MPD Inrush and Power-On Baseline Text

Michael Paul

MPD Inrush / Power On State Machine

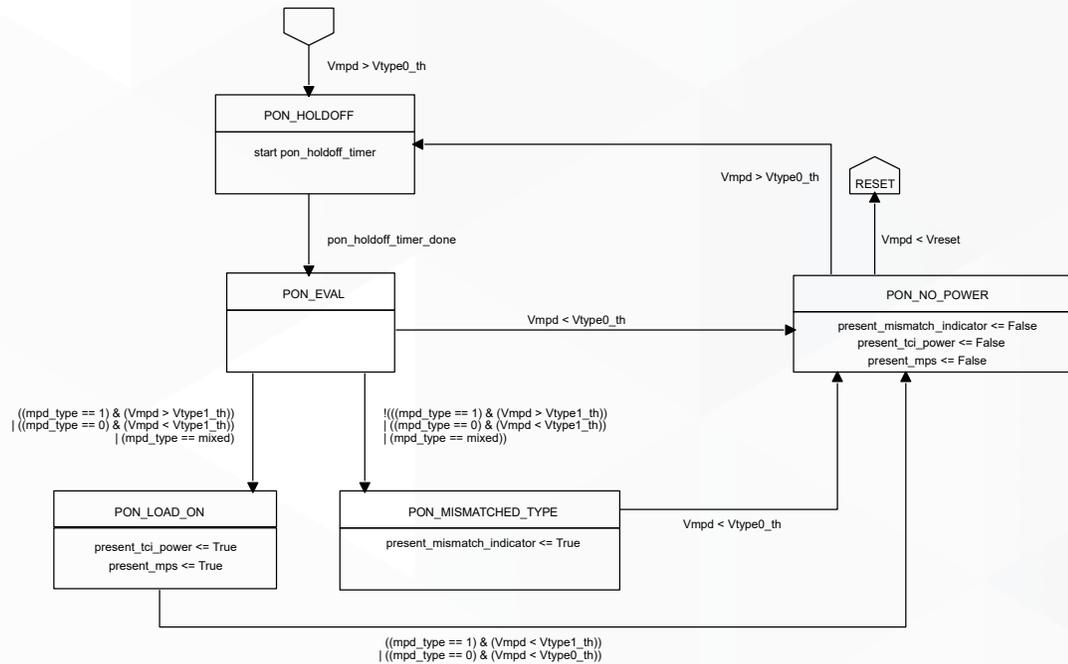
- Add inrush state machine
 - Added variables and timers
- Update Table 169-7 w/ power regions
 - Items 1, 2, 4, 5
- Update text in 169.5.7.1 MPD Inrush

States	Description	State Actions
pon_holdoff	A State to allow power on voltage to settle on the mixing segment before MPDs begin inrush	start pon_holdoff_timer
pon_eval	Evaluation state at the end of pon_holdoff. MPD determines if TC3 interface voltage is compatible with MPD type.	
pon_mismatched_type	MPD has operating voltage applied, but it is not in the correct range for the load. MPD does not enable its load and provides active indication to the user that the MPD is connected to incompatible system type	present_mismatch_indicator <= TRUE
pon_load_on	Power is being delivered to the MPD load. Power is limited by MPD type.	present_TCI_power <= True, present_mps <= True
pon_no_power	Interface voltage has dropped below the level where power can be delivered. This may happen momentarily and not affect the node (depending on rectification and bulk cap) or it may cause the MPD to reset its application load. An MPD shall continue to operate through a power supply disruption of TBD time.	presentn_TCI_power <= False, present_mps <= False, present_mismatch_indicator <= False

Variables	
Vtype0_th	Threshold between discovery region and type 0 power region
Vtype1_th	Threshold between type0 power region and type 1 power region
Timers	
pon_holdoff_timer	A timer used to prevent inrush from starting after MPD voltage has crossed into the power on regions
